NATIONAL IMAGERY TRANSMISSION FORMAT STANDARD (NITFS) REQUEST FOR CHANGE (RFC)

RFC CONTROL NUMBER	96-011A	DATE SUBMITTED	07/21/96	DATE RECEIVED
ORIGINATOR	Joint Interoperability Test Command	MAILING	JITC	
TELEPHONE	(520) 538-5458	ADDRESS	NITFS CTE FACILITY FORT HUACHUCA, AZ 85613-7020	
ORGANIZATION TYPE	Government (DoD)			
PRIORITY		FUNCTION		
		Administrative		
DOCUMENT NUMBER	JIEO CIRCULAR 9008	PAGE	5-29	
DOCUMENT	<u>NITFS CERTIFICATION TEST & EVALUATION PROGRAM PLAN</u>	PARAGRAPH	5-24.L	
<u>PROBLEM DESCRIPTION</u>				
Criteria for the TACO2 physical interface are not sufficiently specific.				
<u>RECOMMENDED WORDING</u>				
See Attached.				
<u>RATIONALE</u>				
Criteria need to be more specific to help ensure that all TACO2 implementations are capable of operating with the majority of military communications systems.				
<u>REMARKS</u>				
The NITFS CTE Facility has been testing according to the requested change since the Spring of 1995.				
TOTAL COST OF IMPLEMENTATION~ Minor		PROPOSED TIMEFRAME OF IMPLEMENTATION Immediately

Figure 5-X. Control Lead Timing Sample of an entire Full Duplex Transmission.

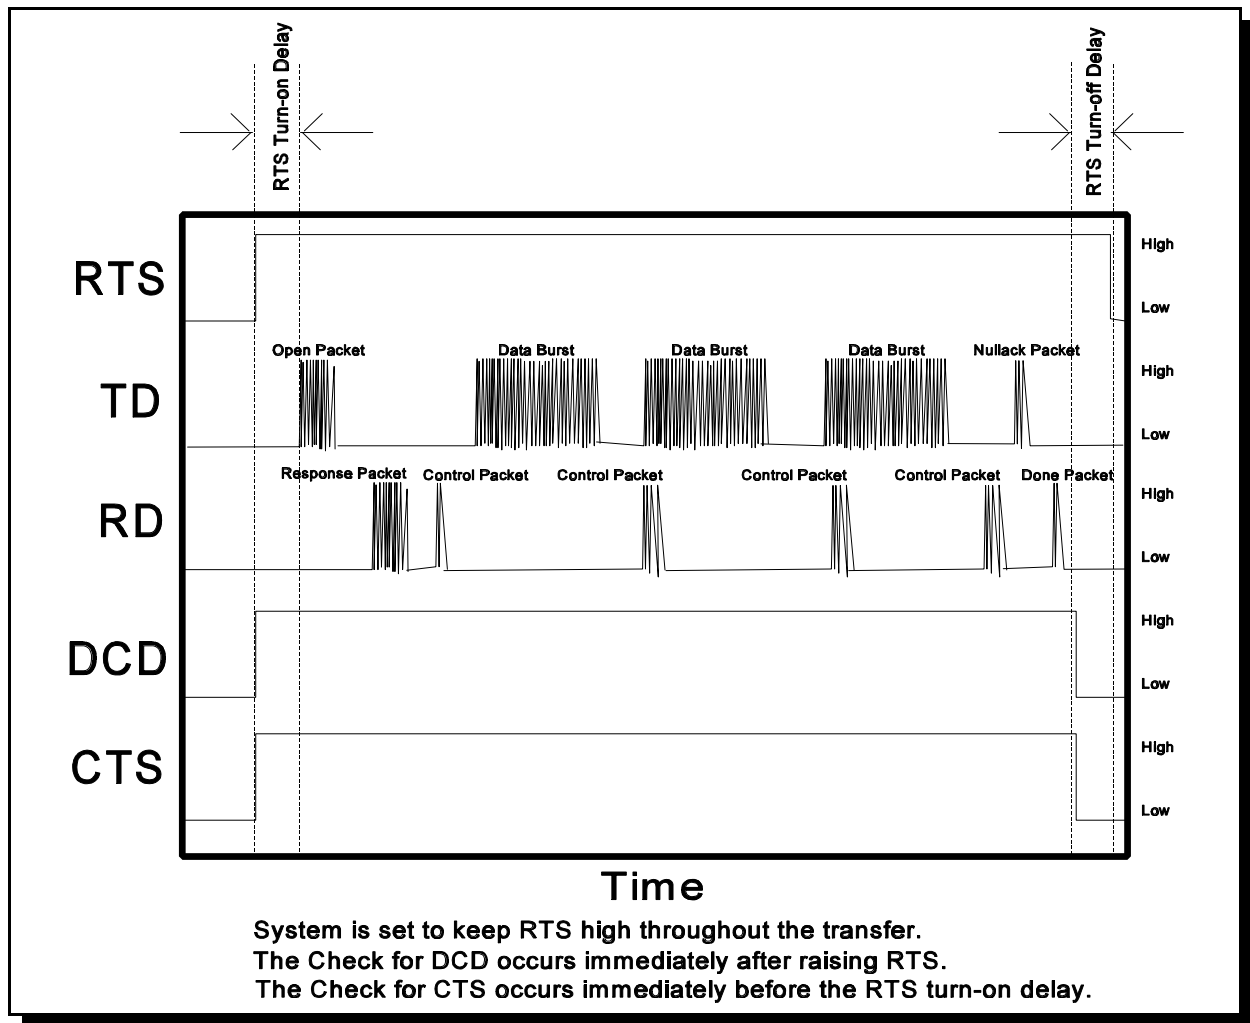
L. The TACO2 implementation must support the following operation, delays and waits for RS-232C (or equivalent) control signals as specified. Figures 5-X and 5-Y show control lead positions and delays from sample TACO2 traffic.

1. **RTS (Request-to-Send).** RTS must be held high while data is being transmitted. The implementation must have a means to wait a user-selectable amount of time after raising RTS and before transmitting data (RTS turn-on delay). The implementation must also have a means to wait a user-selectable amount of time before lowering RTS after transmitting data (RTS turn-off delay). All delays (i.e., RTS turn-on delay, RTS turn-off delay, and half duplex turn-around delay) must be user selectable from 0 to 10 seconds in intervals no larger than 200 milliseconds. The physical control lead response must have an accuracy of ± 200 milliseconds of the delay setting..

a. **Full Duplex.** In full duplex mode, RTS may either be kept high throughout the transfer or lowered between buffers or bursts.

2. **CTS (Clear-to-Send).** The implementation may have an option, which can be disabled, to check and wait for CTS to be high before transmitting. When enabled, the check for CTS must occur after RTS is raised and before initiating the RTS turn-on delay.

a. **Full Duplex.** When enabled, in full duplex mode, the implementation must check and wait for DCD to be high. In full duplex mode, the check for DCD must occur after raising RTS and before checking for CTS to be high (if the CTS check is enabled) and before initiating the RTS turn-on delay.

4. DTR (Data-Terminal-Ready). The implementation must hold DTR high while in receive mode and while transmitting a file. ~~The implementation may have options to pulse DTR (i.e., drop DTR and then immediately raise it) between bursts, or to keep DTR high after completing a transfer.~~ The DTR lead may be used as a resync line when connected to the communications equipment's resync line. If DTR is tied to a resync line, the implementation must pulse the DTR line between bursts or buffers as required to cause the equipment to resync (e.g., the KG-84 requires high voltage for at least 20 milliseconds). If the DTR line is not used as a DTR signal, DTR may need to be tied high on the communications equipment.

Figure 5-Y. Control Lead Timing Sample from a Half Duplex Transmission.

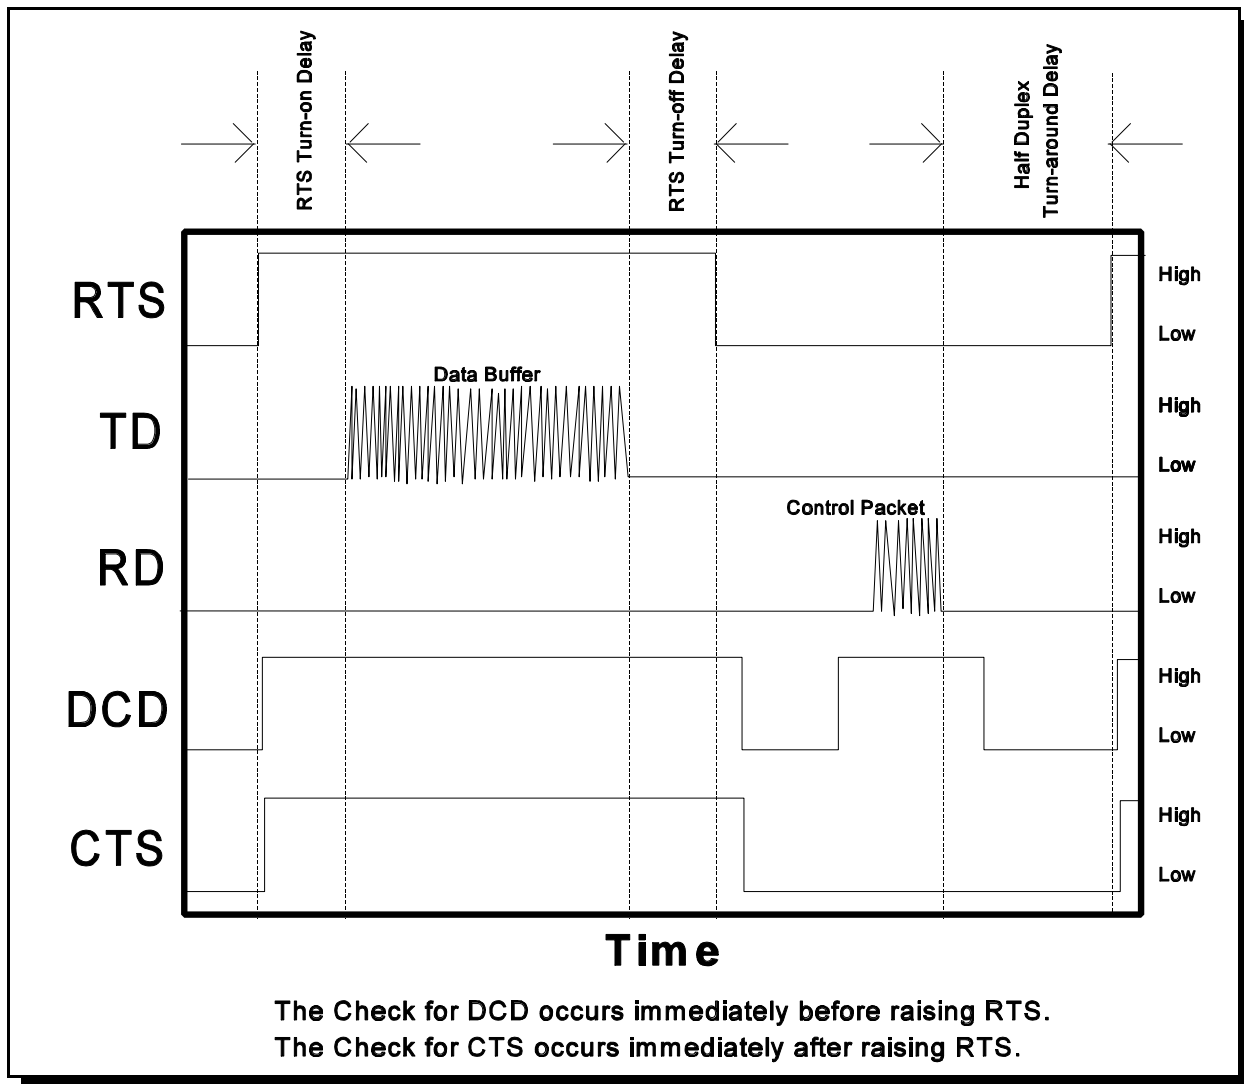
b. **Half Duplex.** In half duplex mode, RTS must be kept low between buffers to allow for incoming packets to be received. In half duplex mode, the implementation must wait a user-specified amount of time (half duplex turn-around delay) before checking for DCD to be dropped low (if the DCD check is enabled) and raising RTS.

b. Half Duplex. When enabled, in half duplex mode, the implementation must check and wait for DCD to be low after the half duplex turn-around delay expires and before raising RTS.
